4156C-05

S E R V I C E N O T E

4155C Semiconductor Parameter Analyzer
4156C Precision Semiconductor Parameter Analyzer

LCD Picture Intermittently Reverses or is not Displayed

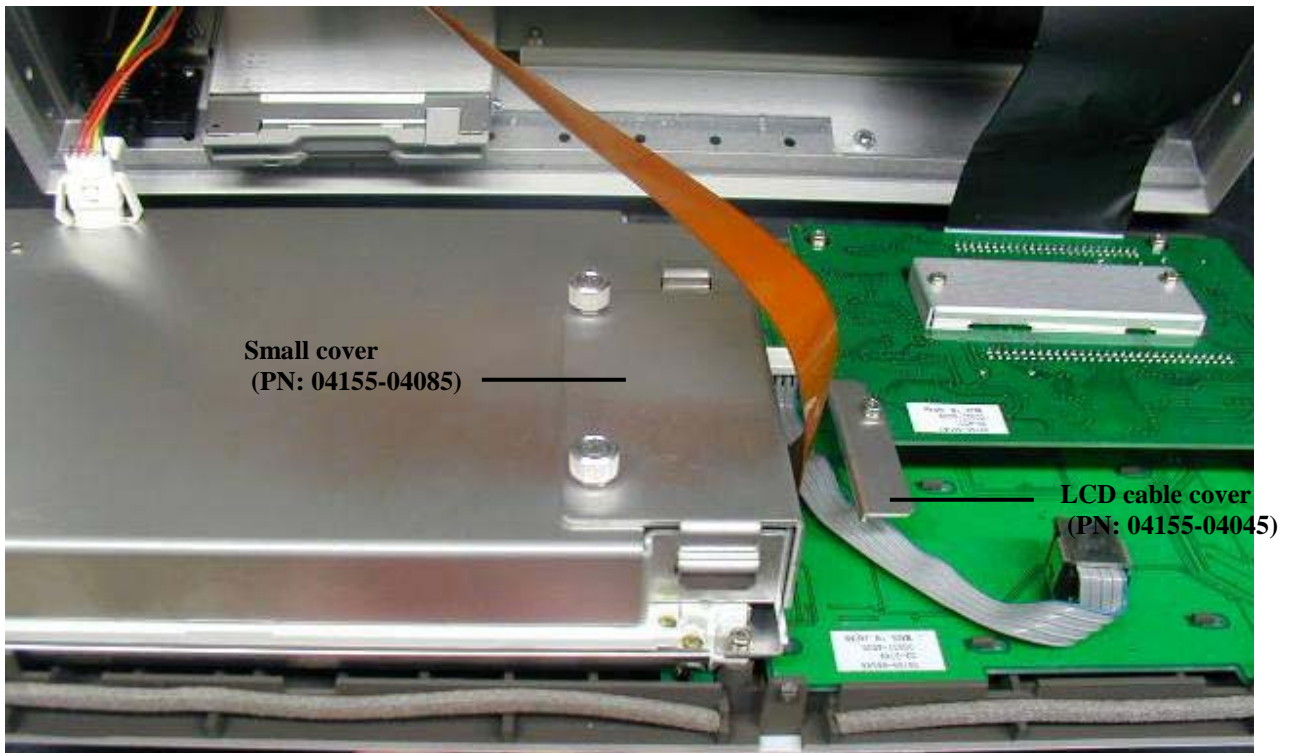
The 4155C within the listed serial number range may have the problem that the LCD picture intermittently reverses or is not displayed. The cause of the problem is that the PC board stresses the LCD cable, and the cable connection becomes loose. Though we have released service note 4155C-04 and 4156C-04, it is not enough.

After adapting service note 4155C-04 or 4156C-04, replace the original cable cover (small: 04155-04085) with a set of 04155-24060, 04155-04086, and 04155-04087. To replace with this set, the flexible video cable will be fixed enough.

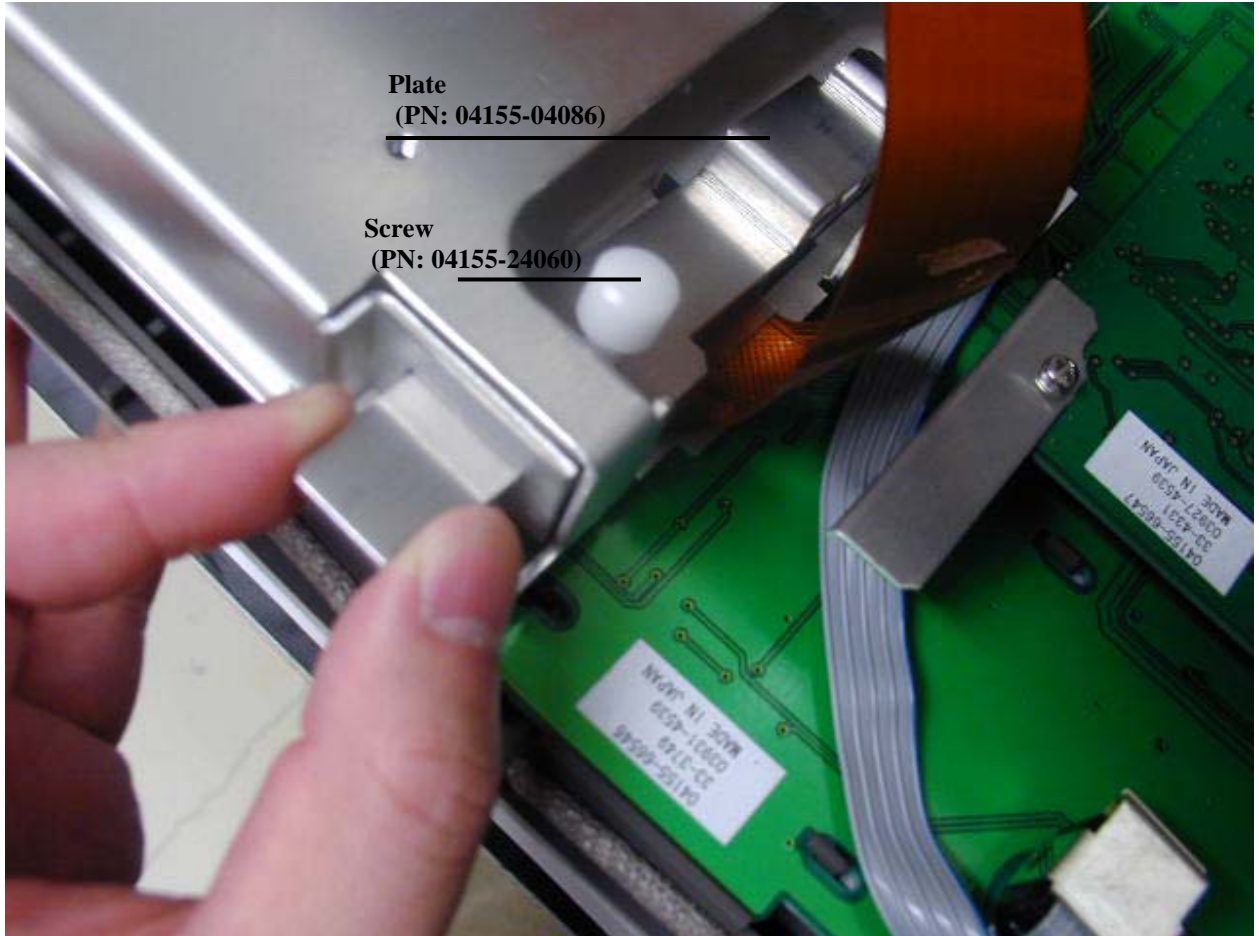
3. Remove the original small cover 04155-04085

4. Insert the plate (PN: 04155-04086) and fix it using screw (PN: 04155-24060).

5. Install the new small cover (PN: 04155-04086).
6. Perform the diagnostics Interactive Test "LCD Test".
